**STAFF RECOMMENDATION**

**1405 Russell Street**

**August 18<sup>th</sup>, 2021**

**Application:** New Construction-Addition/Materials

Figure 1. 1405 Russell Street.

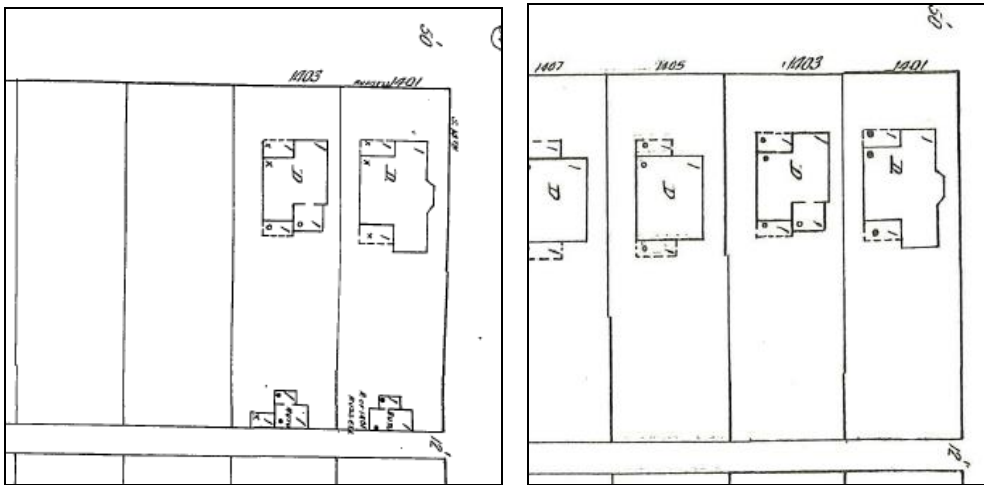
**Background:** 1405 Russell is a c.1951-57 front-facing gabled house that does not contribute to the historic character of the Lockeland Springs-East End Neighborhood Conservation Zoning Overlay (Figure 1). Although the Property Assessor’s page states that the house is from c. 1930, staff’s review of the 1950s Sanborn maps shows that the house was not extant in 1951 but it does appear by 1957 (Figures 2 & 3). The house is a 1950s house.
